CITY OF NORTH PORT

CONTRACT/AGREEMENT AMENDMENT FORM

Amendment No.: 3

Project Name: Water Pipeline Bridge Replacements-Haberland/Woodhaven/N Toledo Blade

UTILITY PLAN AND PROFILE
 (ORTIZ BLVD.)
 2021 WATER PIPELINE BRIDGE REPLACEMENTS
 (HABERLAND / WOODHAVEN / N. TOLEDO BLVD / ORTIZ BLVD)

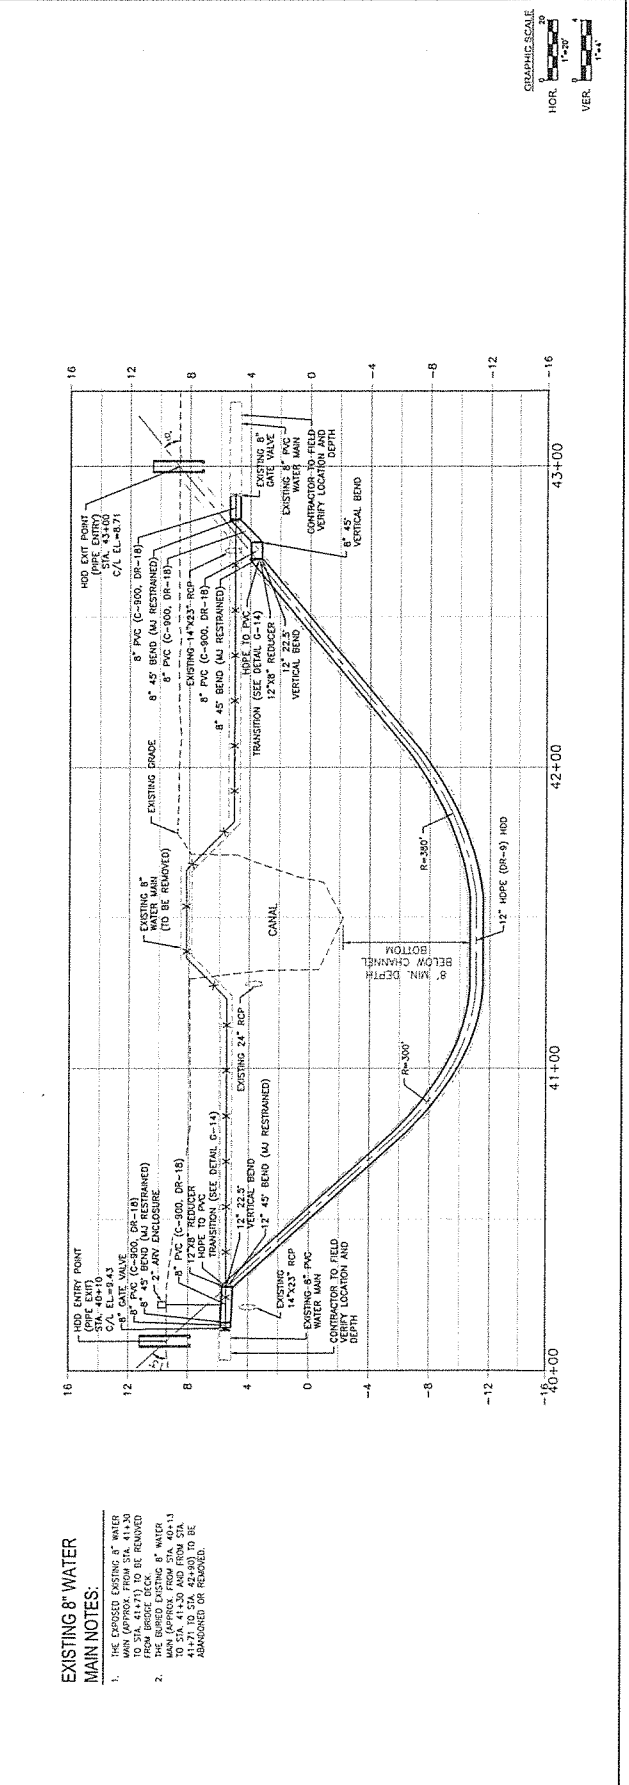
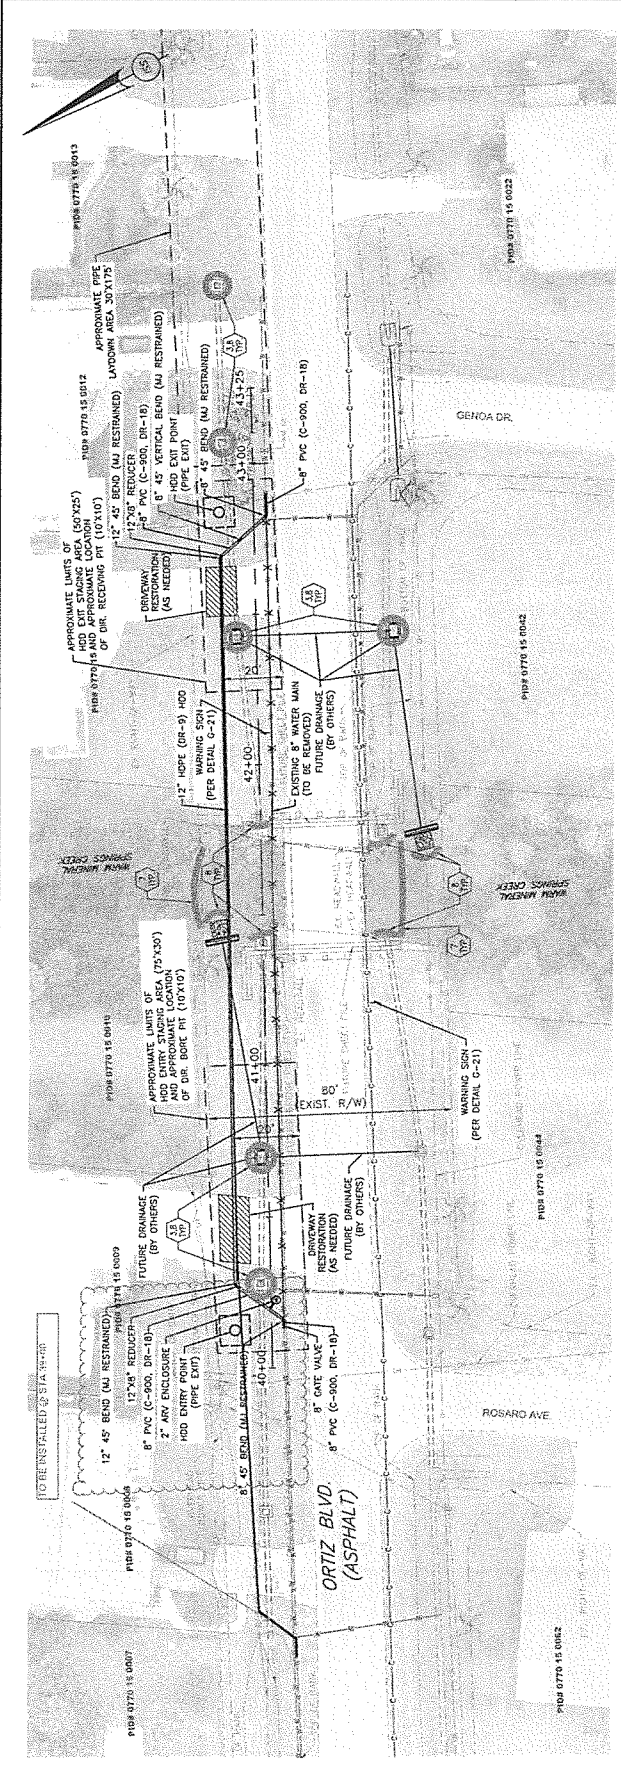
There is a layer of rock 15' to 20' deep at the Ortiz Bridge Bore. The strata will not allow the The bore to turn up or down to navigate the bore path.

Extend bore approx 125 lf farther NW to STA. 39+00 and tie-in as proposed @ STA. 40+25

After discussions with the City, ISS agrees with the Contractors request to extend bore an add'l 125' due to an unexpected rock layer.
